Author response to Referee #1 comments:

Author response to Referee #2 comments:

Reviewing of the manuscript open for discussion ‘EcoTWIN 1.0: A Fully Distributed Tracer-Aided Ecohydrological Model Tracking Water, Isotopes, and Nutrients’ by Songjun Wu et al. submitted to Geoscientific Model Development (Manuscript ID: egusphere-2025-3941).

Figure 1. Model structure of EcoTWIN. As a distributed model, EcoTWIN disentangles the spatial domain into grid cells. In each grid cell, hydrological, isotopic, and nitrogen processes were simulated in canopy, snow, soils, shallow groundwater, groundwater, and channel.

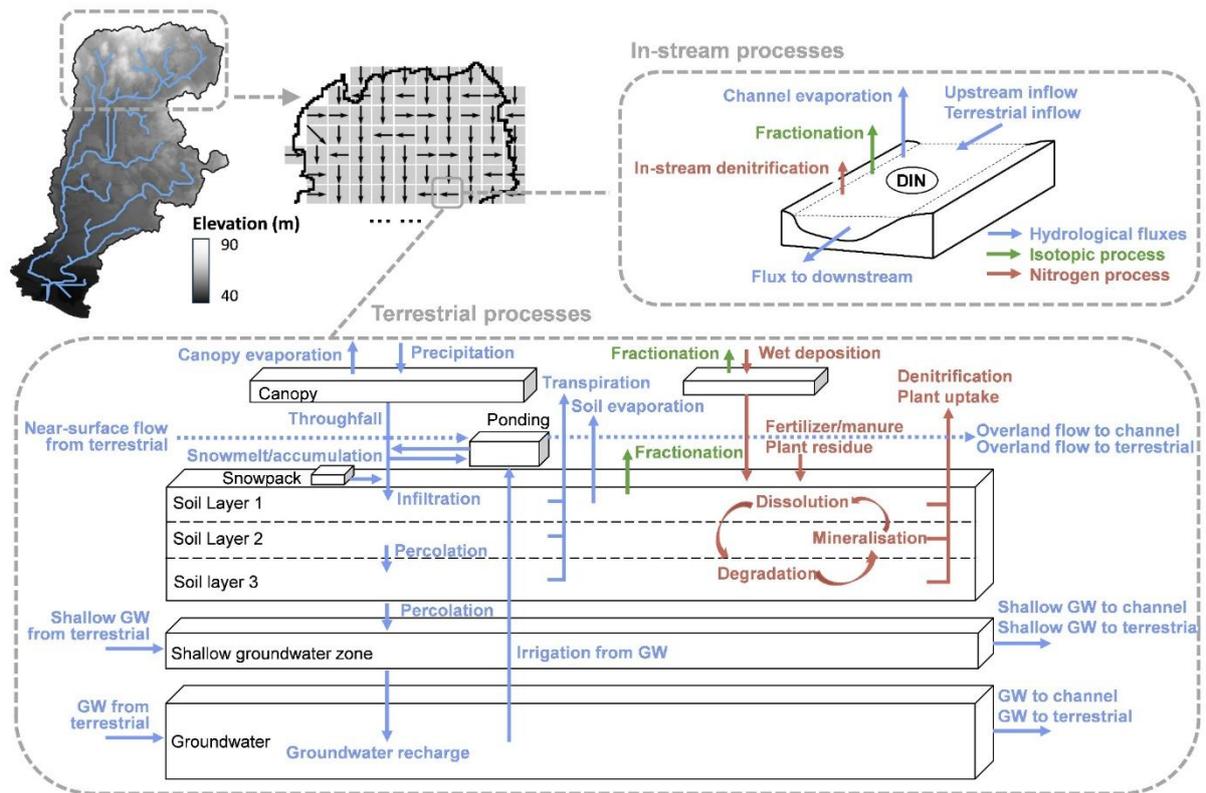
Figure 1. Is soil zone part of vadose zone?

Almost all figures need to be replotted. Here I give some examples. Fig. 1: The texts are too small to read, and the subtitles need add some explanations for the figure, so that the reader is easy to follow it; Fig. 2: the coordinates need to be added, and some important landmarks or rivers information should better be added; the texts are too small to be identified; Fig. 3: the color for the color should be more identifiable, rather than orange and blue two colors; Fig. 4: the time series figures give no information to the reviewer; similar issues also for Fig. 5-7, and the reviewer will NOT list all issues for the figures. The authors should check them carefully and revise them all.

** This storage is separated from soil. We realised the ambiguity to call it “vadose zone”. Therefore, it has been changed to unsaturated zone (like conceptualized in many hydrological models like HBV, mHM, etc.). The term has been corrected through text and plots.

Fig. 1: Irrelevant text has been removed from the inset plot. We have also increased the size of remaining text in inset plot and improved the captions.

Figure 2. The selected catchments for model validation and an overview of key inputs.

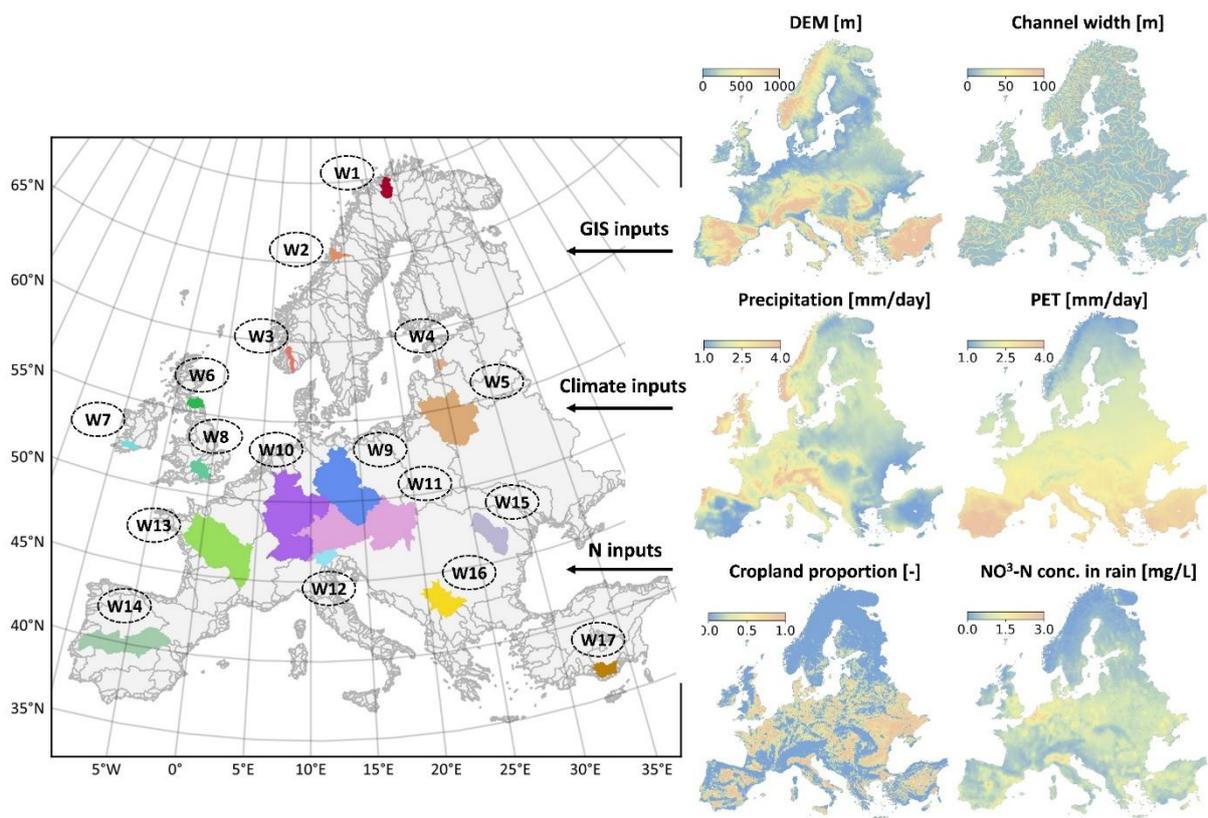
Figure 2: Does not have coordinates. Such as longitude and latitude information.

Line 399: How do you consider the upstream - downstream dependency in discharge, some watersheds are connected based on Figure 2.

** Thank you for suggestions. Longitude and latitude have been added.

** All the watersheds in Figure 2 are exorheic basin, which ultimately drain to the sea. Therefore, there is no interaction or connection between watersheds.

Fig. 2: The coordinates have been added, and text size has been increased. However, we hesitated to add river information for two reasons: (1) the figure is already crowded, and (2) adding only major rivers will potentially mislead readers on the actual dense network in our distributed modelling.

Figure 4. The simulated (blue) and observed (orange) time series of discharge, isotopes, and NO₃-N at representative gauges. Note that the sites with relatively poor performance (KGE < 0.2) were particularly shown for model diagnosis.

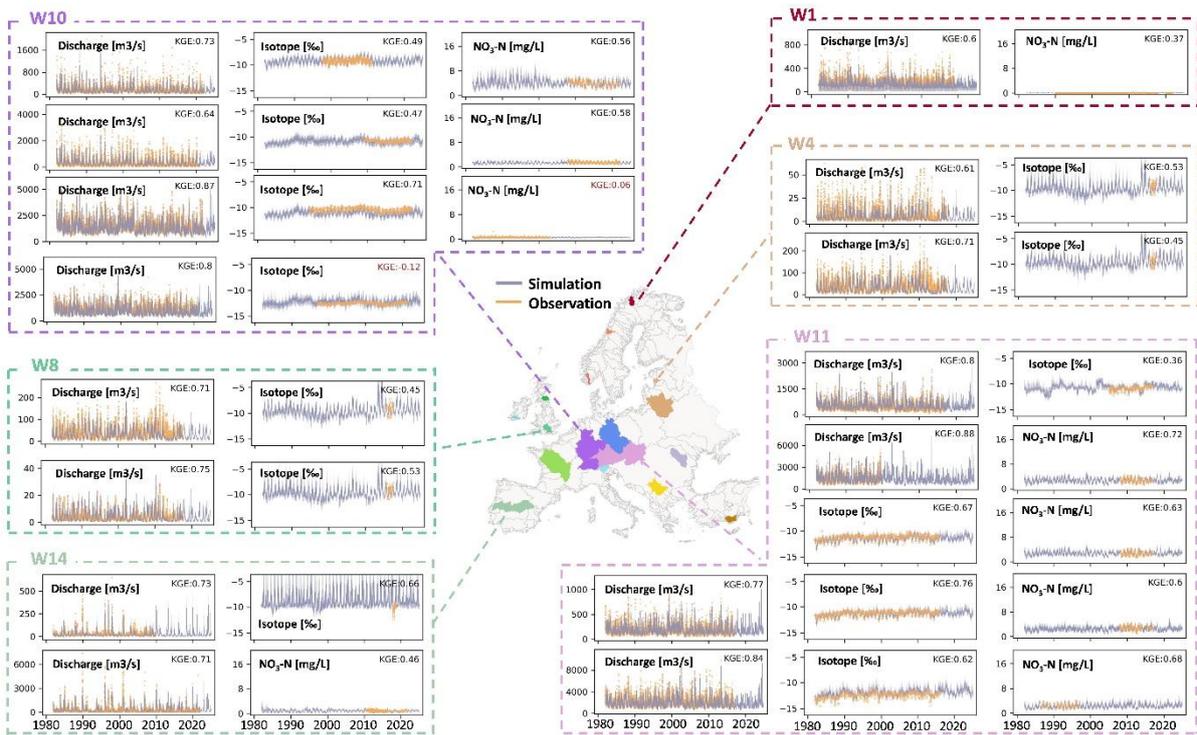
Figure 4: Show line/color meaning in the Figure as well. Also missing time step information.

The subfigures are too small to read. Maybe move some into SI and only show a few here.

** Yes, Agreed. We have added legends for line/color and remove some subplots to reduce the image size. The main message remains unchanged.

Fig. 4: We respectfully argue that the time series gives readers intuitive impressions of the model's performance. But we have reduced the number of subplots for simplicity.

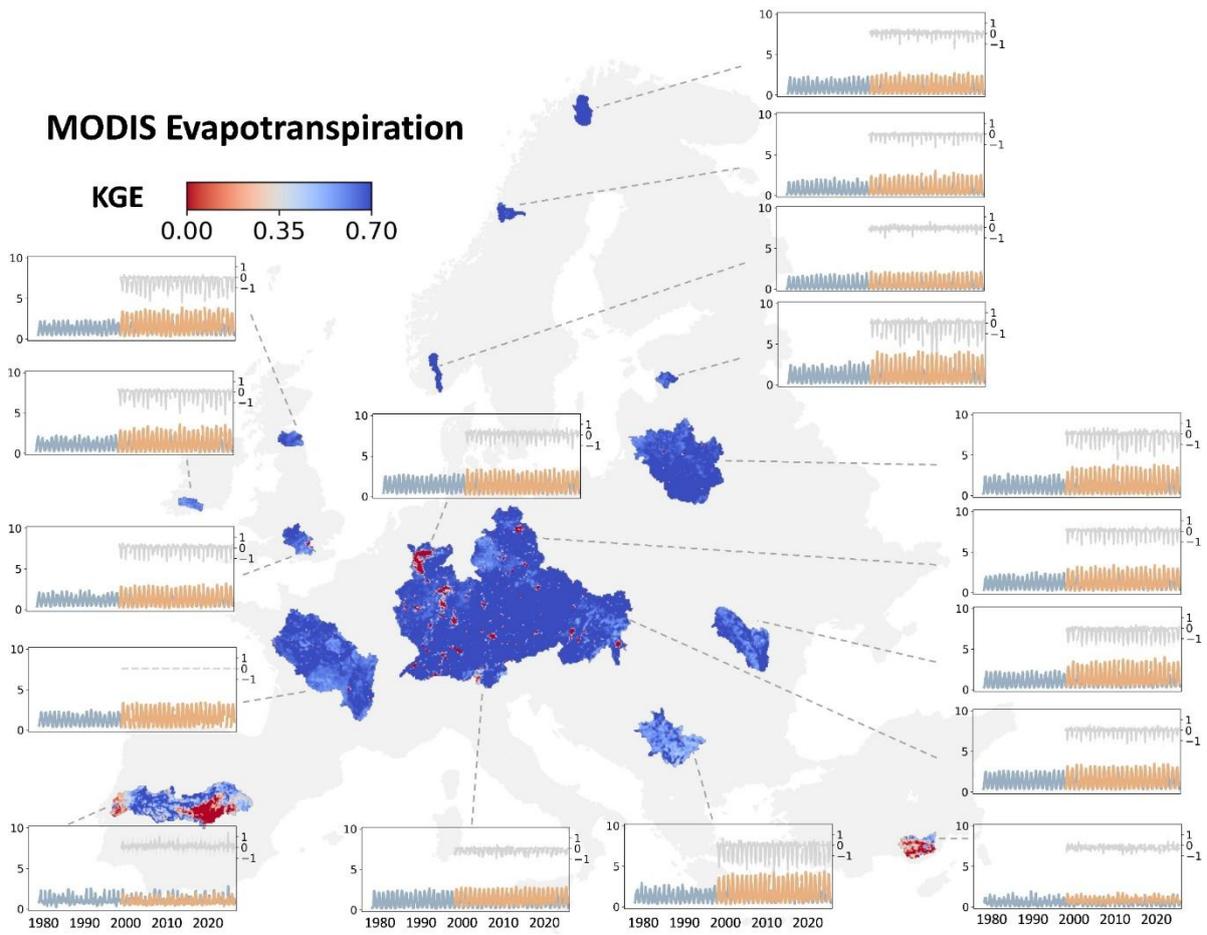
Figure 5. Is the time series watershed averaged? If so, the caption should mention that.

** Agreed. The captions have been revised for Figure 5, 6, and 7.

Fig. 5-7: The spatial plots show model performance in each grid cell compared to three remote sensing products. These are important validations for the ability of a hydrological model to reproduce uncalibrated hydrological fluxes, or namely the physical consistency. Therefore, we keep the three figures. The ambiguity may originate from the misleading color code of the spatial map, which has been changed to "cool-warm" to differentiate from the inset subplots.

Figure 6. The grid-to-grid comparison between simulated water storage anomaly and GRACE surface water mass anomaly. The time series show the monthly dynamics of simulated (blue) and observed (orange) values averaged from all grid cells in the watershed, as well as their deviations (grey).

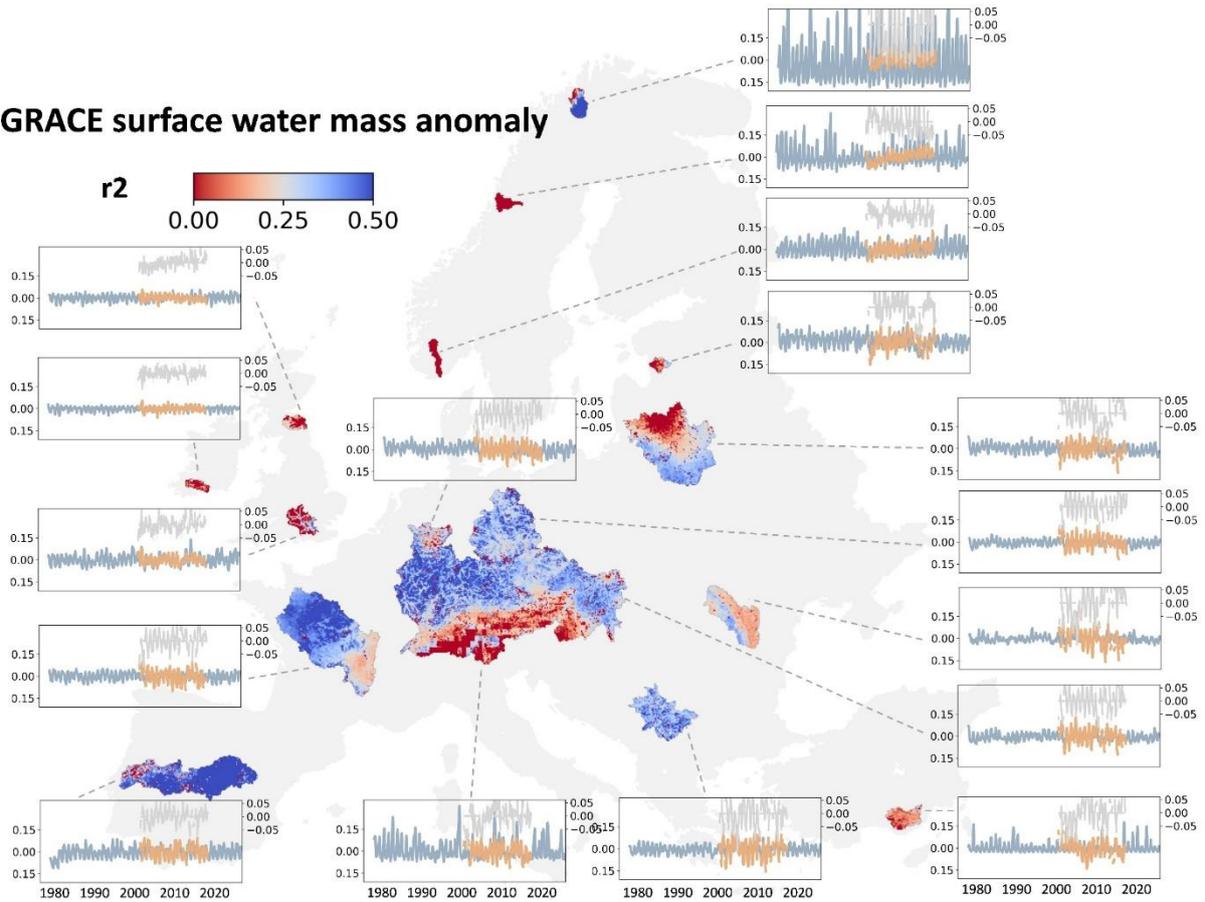
Figure 6: The GRACE datasets resolution might be too coarse for comparison; there need to be some justification somewhere. Check other spatial products as well, maybe a table listing all produce with original and resample resolution for reference.

** Yes, we also agree that the coarse resolution of GRACE might be the reason for poor performance in validation. This is now discussed in section 5.1.3.

“There are two potential reasons: (i) the coarse resolution of GRACE might account for mass shifts in both ocean and land, yet EcoTWIN only produces mass anomaly in terrestrial systems; (ii) bidirectional fluxes across the land-ocean interface might drive key changes in coastal systems, which is not considered in current version of EcoTWIN.”

Figure 7. The grid-to-grid comparison between simulated snow depth and ERA5 snow depth. The time series show the monthly dynamics of simulated (blue) and observed (orange) values averaged from all grid cells in the watershed, as well as their deviations (grey).

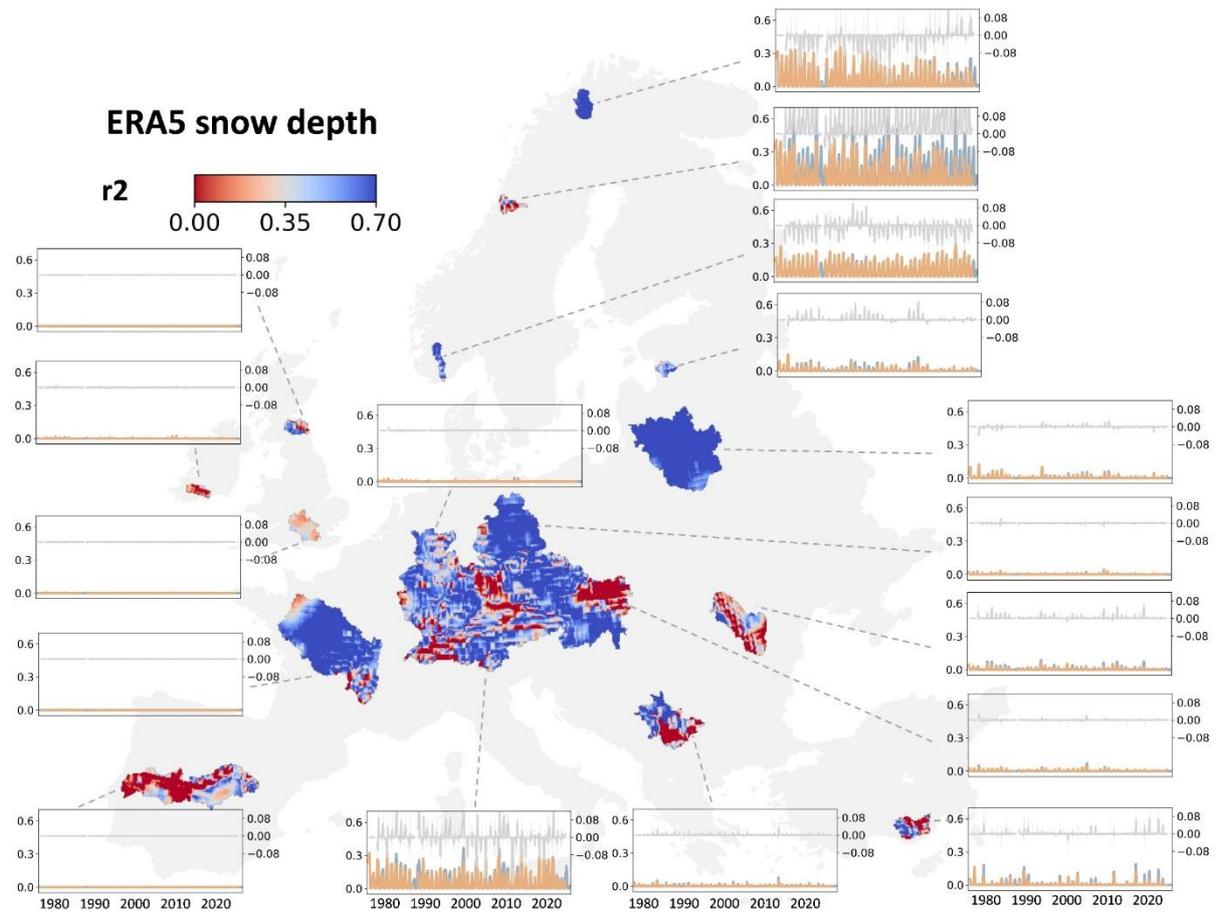
Line 451: ERA5 reanalysis products equal to observations? Please double check it.

** Yes, the snow depth simulated in model and in ERA5 reanalysis is commensurable, but there are still uncertainties and differences between ERA5 products and real observations. We now use “ERA5 records” to avoid ambiguity.

Finally, the simulated snow depth was compared to the daily snow depth in ERA5 reanalysis products (ERA5 post-processed daily statistics on single levels; 10.24381/cds.4991cf48). Results in Figure 7 show a good agreement between simulations and ERA5 records in most regions with $r^2 > 0.5$, though degradation was found in a few catchments.
